# **Desktop Board CC820 Specification Update**

Release Date: June 2000

Order Number: 749730-004

Figure 16. Location of the Jumper Block

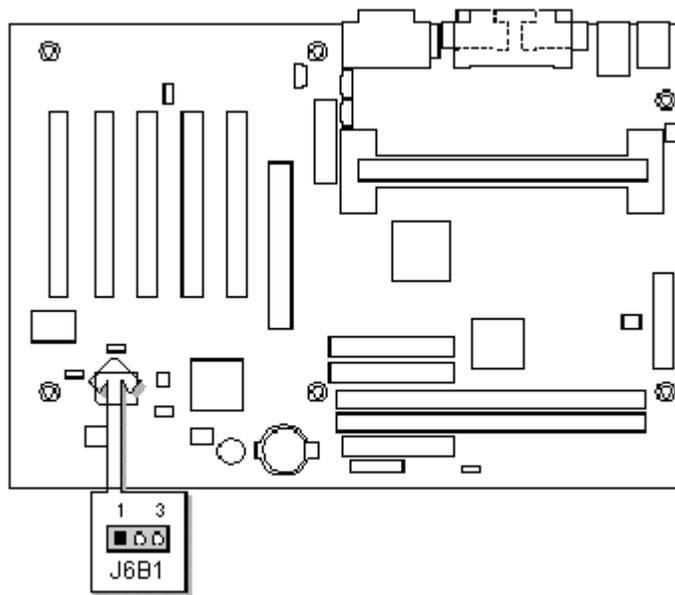
## 2. Add Control Jumper Block

Section 2.9.1, figure 16 and Table 47 will be added to the CC820 Technical Product Specification. All subsequent table numbers and figure numbers will be updated.

### 2.9.1 S5 Control Jumper Block

The addition of jumper block J6B1 provides additional user control over system wake events. When the jumper is in its default location (shorting pins 1-2) the system will resume from S5 when a PME or WOL event is asserted. If the jumper is placed on pins 2-3 the system will no longer resume from S5 when PME or WOL events are asserted. This jumper does not in any way impact S3 resume events. *Please note that in order for the system to resume from S5 the operating system and drivers must also be configured to enable these wake events.*

**Table 47. S5 Control Jumper Settings (J6B1)**

Function/Mode	Jumper Setting		Configuration
Enable S5 wake events.	1-2	<div style="display: flex; justify-content: space-around; align-items: center;"> <span>1</span> <span>3</span> </div>  <p><i>(Default)</i></p>	System will resume from the S5 power state when a PME or WOL wake event is asserted.
Disable S5 wake events.	2-3	<div style="display: flex; justify-content: space-around; align-items: center;"> <span>1</span> <span>3</span> </div> 	System will NOT resume from the S5 power state when a PME or WOL wake event is asserted.
